CHANGES SUBMISSION. SET-2

Pool Terrace Changes. DRC Meeting Package Submission - **01-13-2015**

**Proposed Student Housing at Tyndall Avenue**

The Hub at Tucson II

Proposed Rooftop Plan

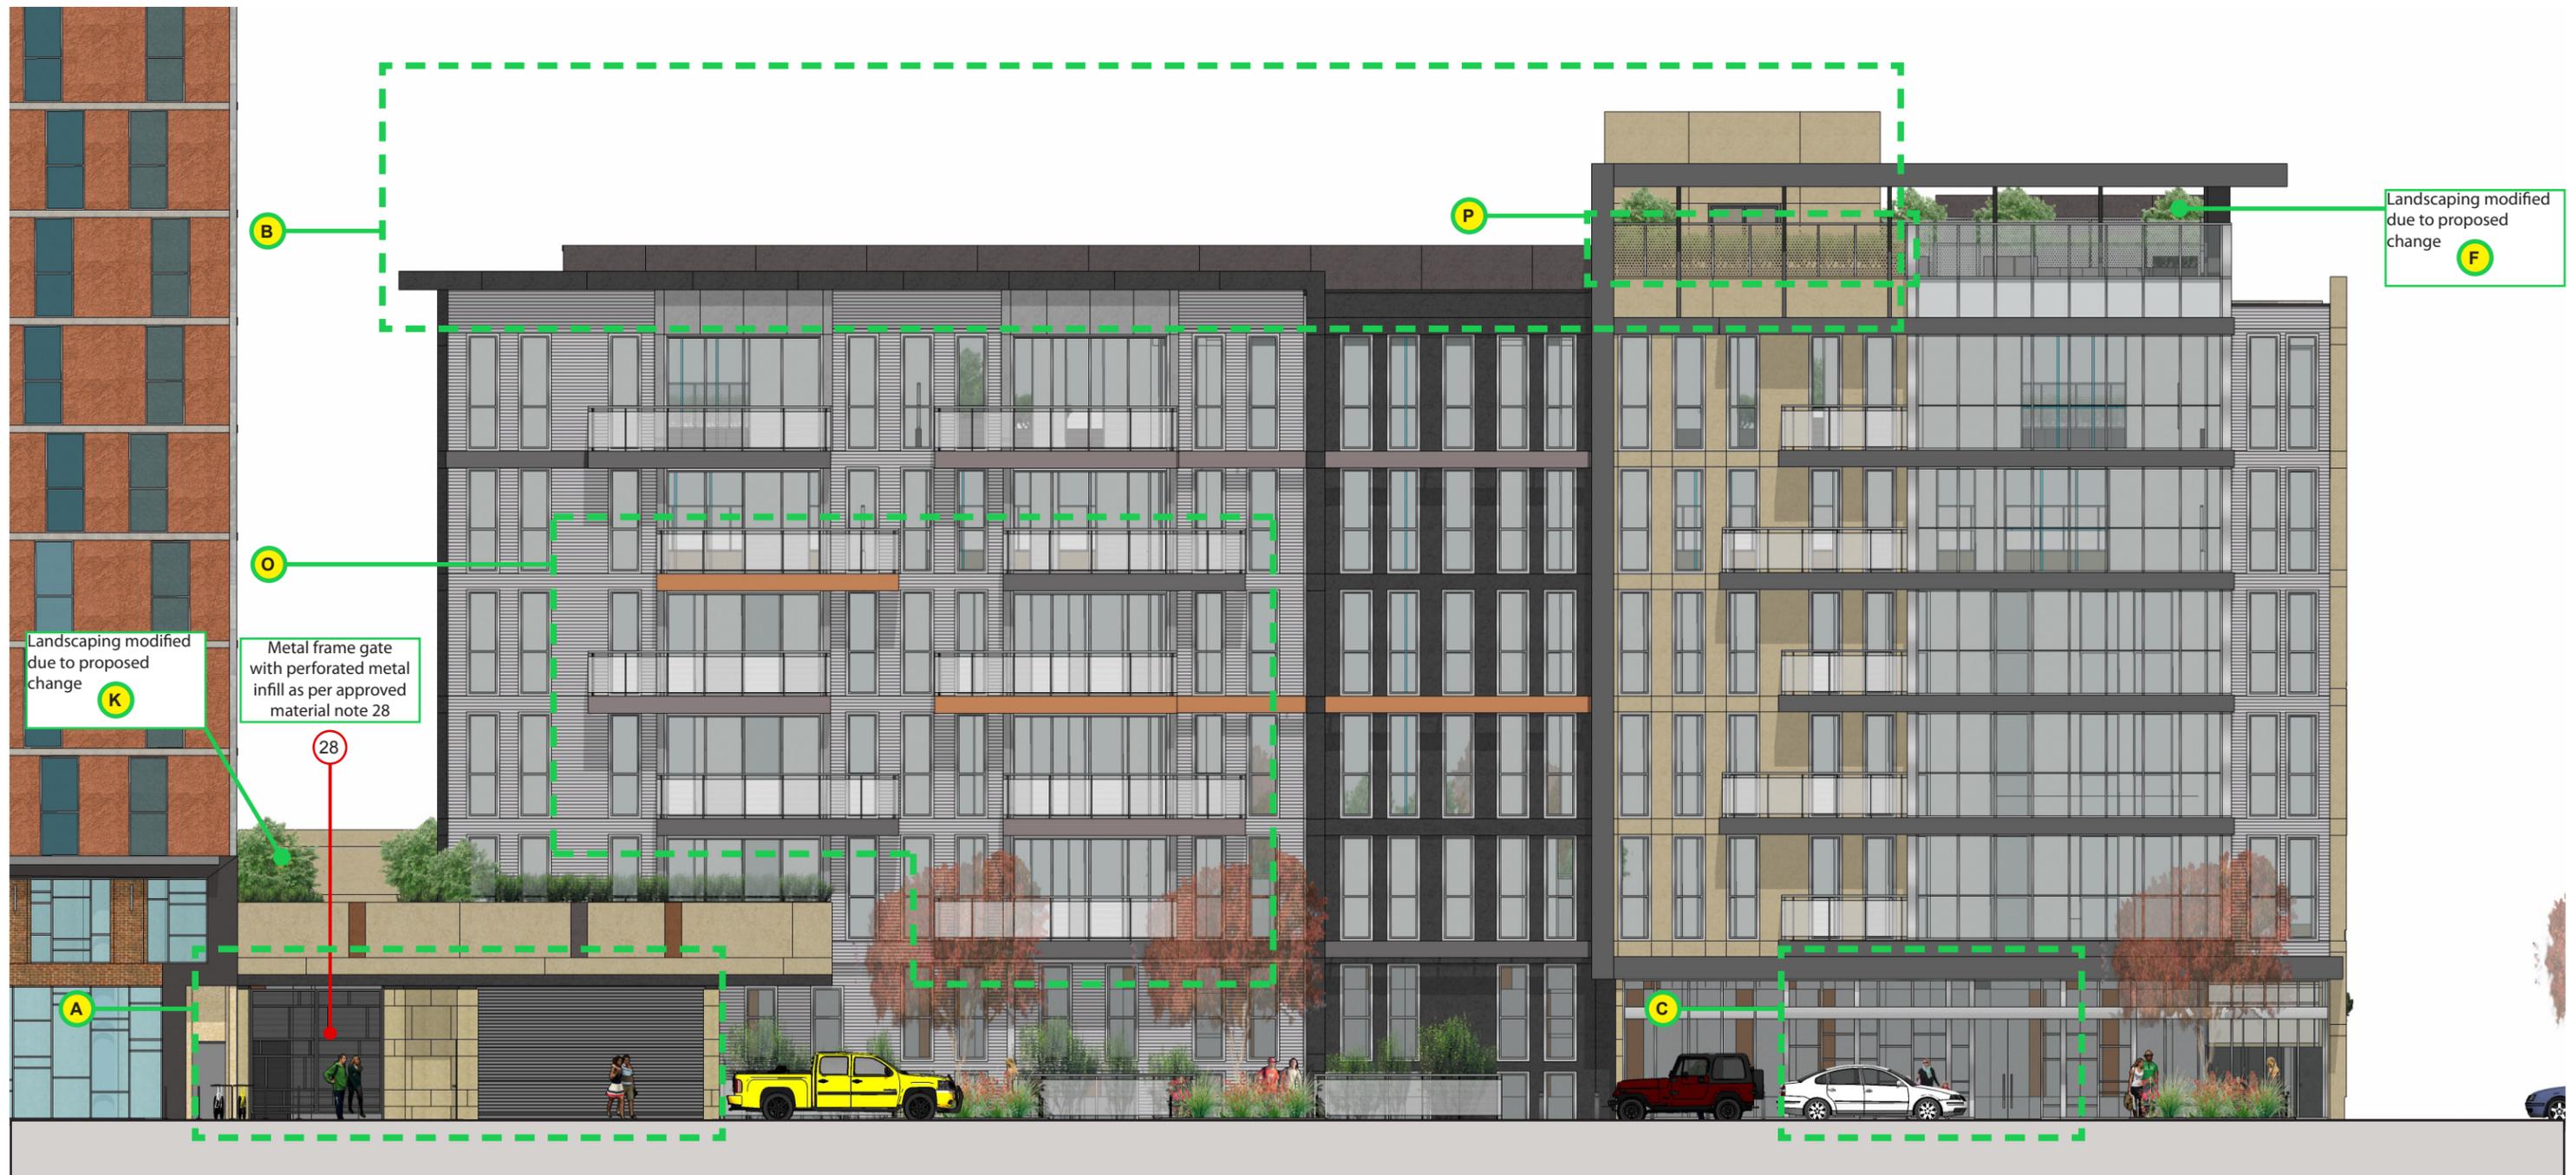
- **A** - Water meter enclosure and transformer room relocated from west alley to the Tyndall street facade. Garage door size reduced.
- **B** - Mechanical screen altered. Secondary screen removed and parapet height increase to 5' to act as screen, pool equipment room removed, elevator shaft footprint reduced and the elevator top of parapet height increased from 86' to 90' to allow for the mechanical lift overrun. 6th floor ceiling height increased by 1' with the south "I" eyebrow lifting by approx 1'10".
- **C** - Residential entry lobby and entry doors revised.
- **O** - Occupiable area of balconies reduced.
- **P** - Stucco cladding changed to perforated metal.

Proposed East Elevation

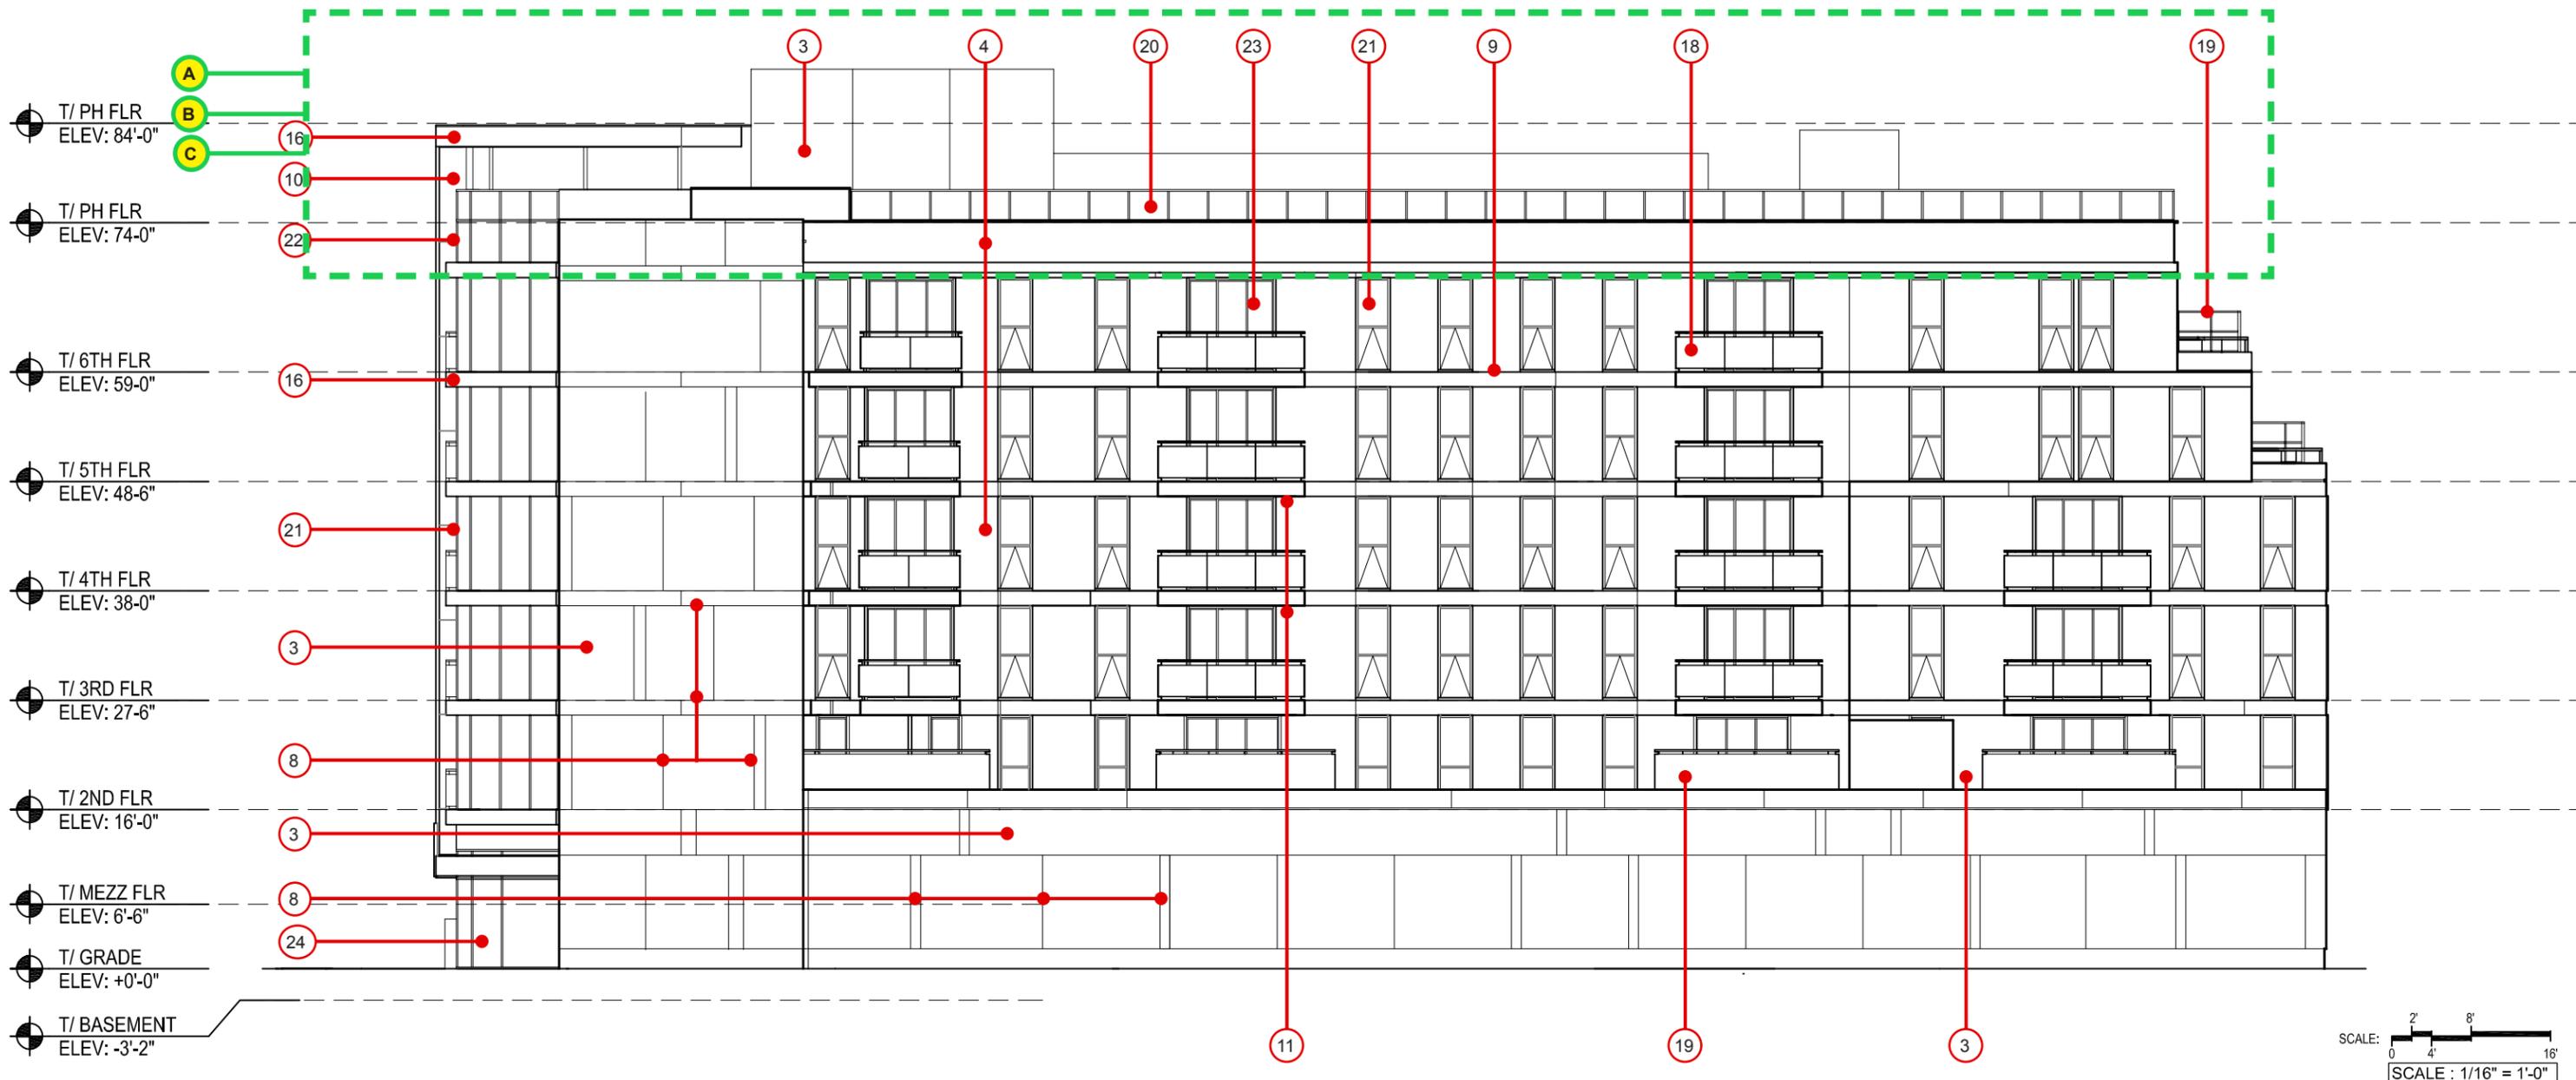
- **A** - Original height of 6th floor ceiling level reinstated.
- **B** - Mechanical screen altered. Secondary screen removed and parapet height increase to 6' to act as screen, pool equipment room removed, elevator shaft footprint reduced and the elevator top of parapet height increased from 86' to 90' 8" to allow for the mechanical lift overrun.
- **C** - Rooftop Pool terrace area reduced, Rooftop terrace screen material changed from glass infill to metal panel infill. Extent of mechanical screen increased to location on the north wing. Landscaping altered to suit new layout.

- **D** - Addition of mezzanine units to the north wing of the building.
- **E** - Duplex units added to center of north wing and balcony arrangement altered. Associated Balconies increase in width from 15' to 18'. Layout and extent of glazing on north façade changed from 3,006 sqf (Approved scheme) to 3,784sqf (Proposed scheme), resulting in 778 sqf of additional glazing.
- **F** - Rooftop terrace area reduced, pool and hot tub relocated to the courtyard. Rooftop terrace screen material changed from glass infill to metal panel infill. Extent of mechanical screen increased to location on the north wing. Landscaping altered to suit new layout.
- **L** - All balconies reduced from 6' to 5' deep, excluding balconies on Tyndall street.
- **Q** - Number of balconies reduced on the north and south elevations from 26 to 16.

GLAZING AREA'S ON NORTH FACADE.	
APPROVED SCHEME TOTAL	3,006 sqf
PROPOSED SCHEME TOTAL	3,784 sqf
GLAZING INCREASE 778 sqf

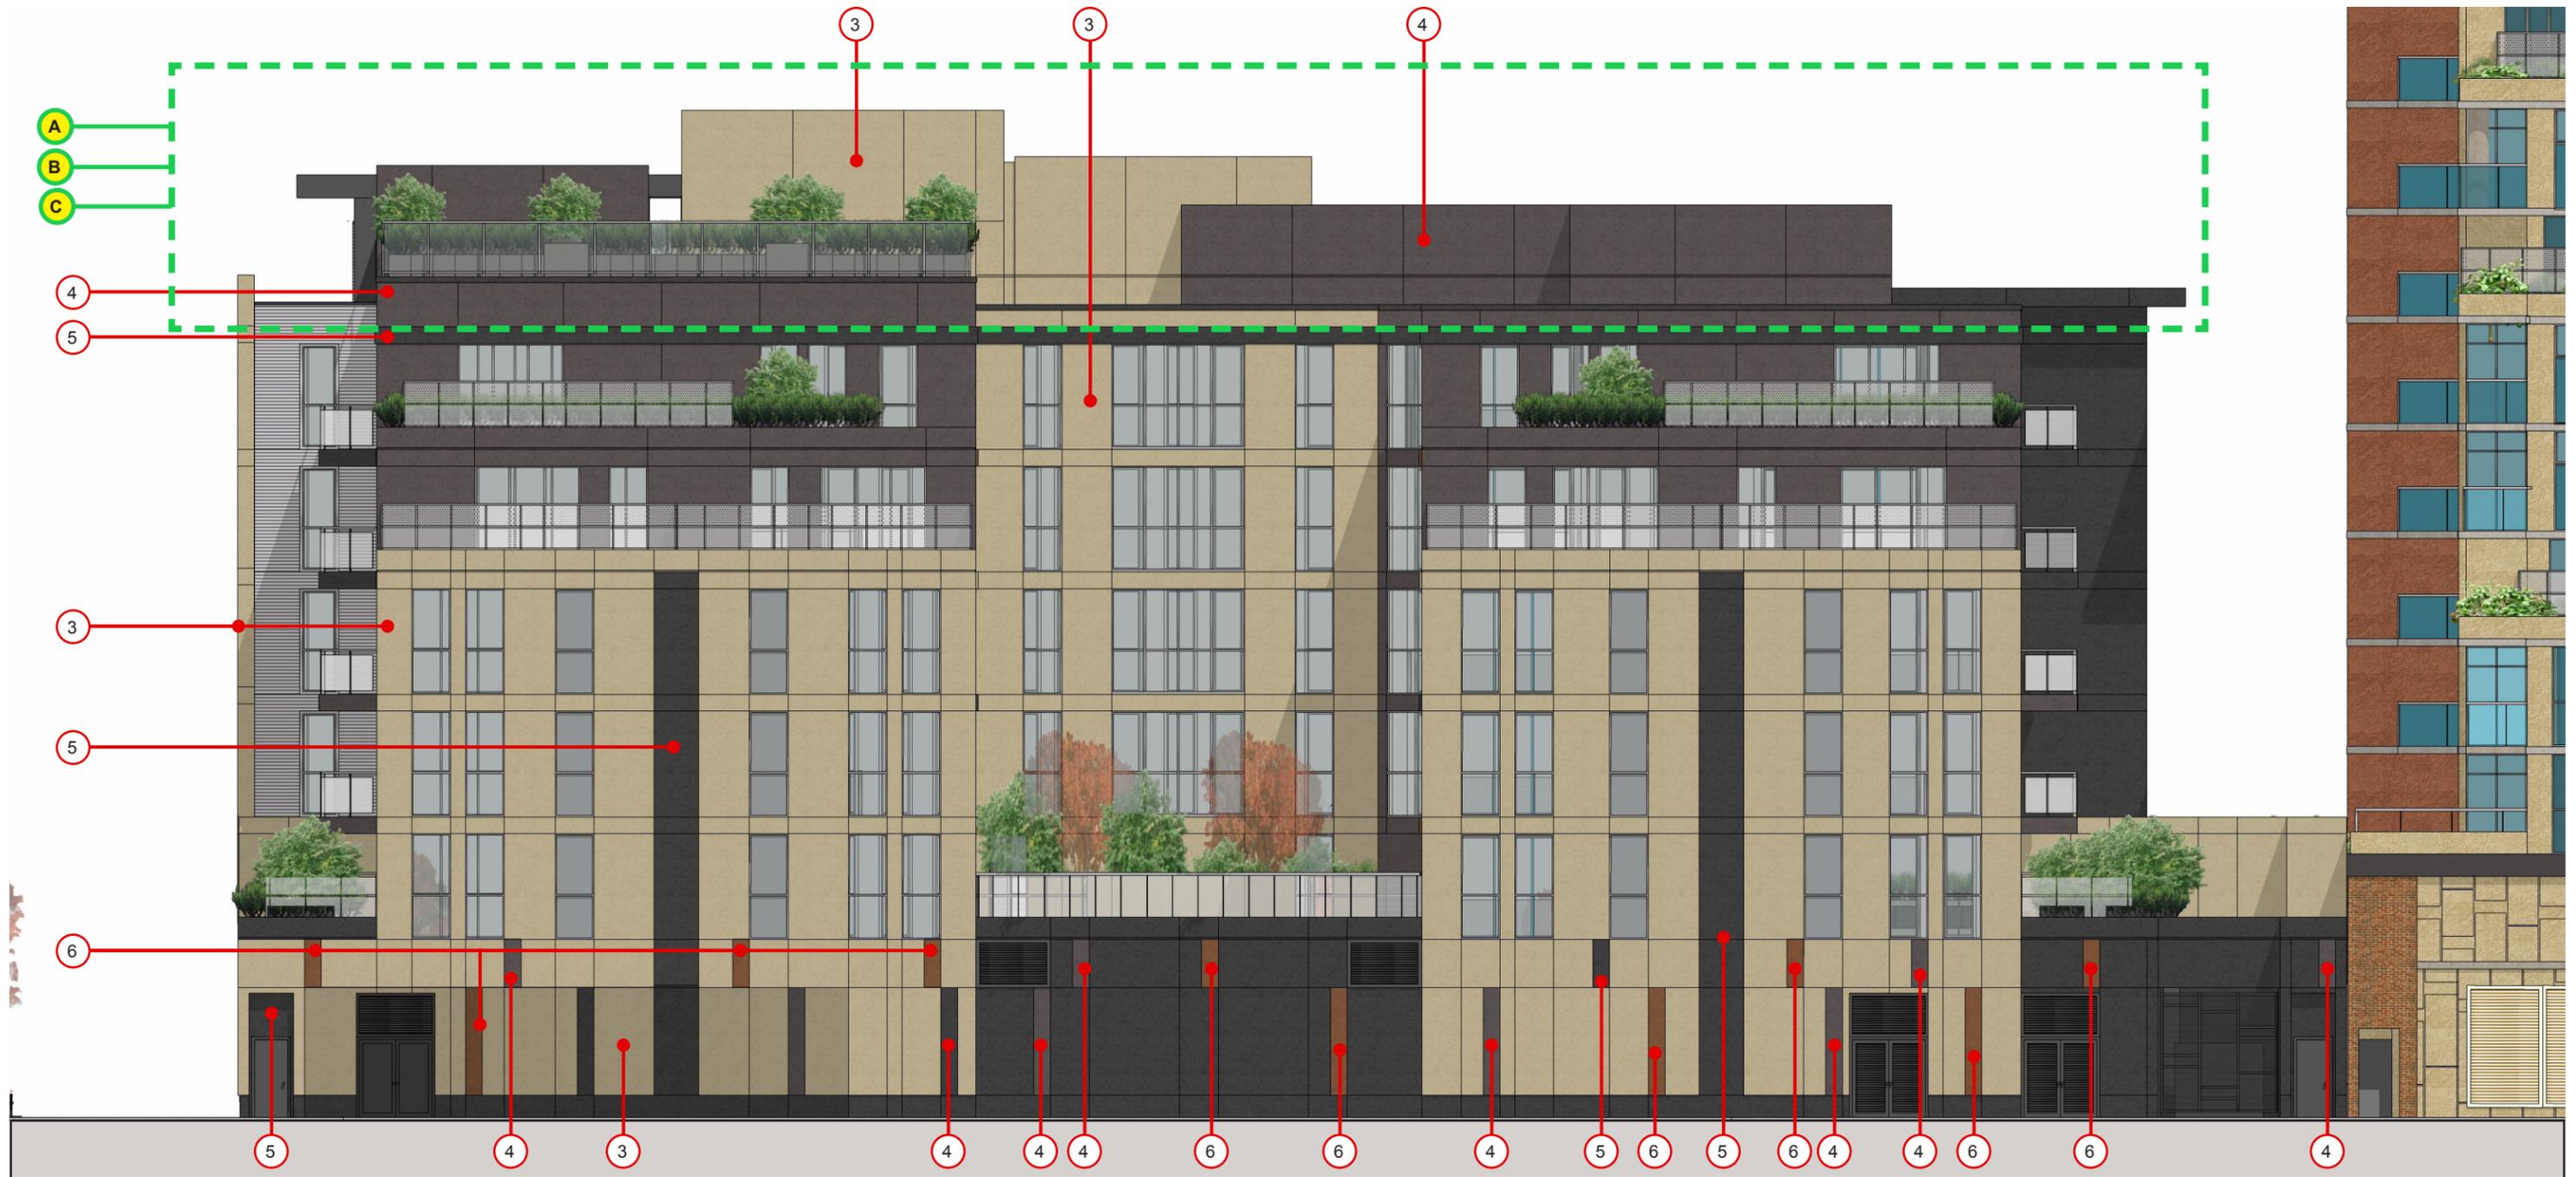
- **A** - Original height of 6th floor ceiling level reinstated.
- **B** - Mechanical screen altered. Secondary screen removed and parapet height increase to 6' to act as screen, pool equipment room removed, elevator shaft footprint reduced and the elevator top of parapet height increased from 86' to 90' 8" to allow for the mechanical lift overrun.
- **C** - Rooftop Pool terrace area reduced, Rooftop terrace screen material changed from glass infill to metal panel infill. Extent of mechanical screen increased to location on the north wing. Landscaping altered to suit new layout.
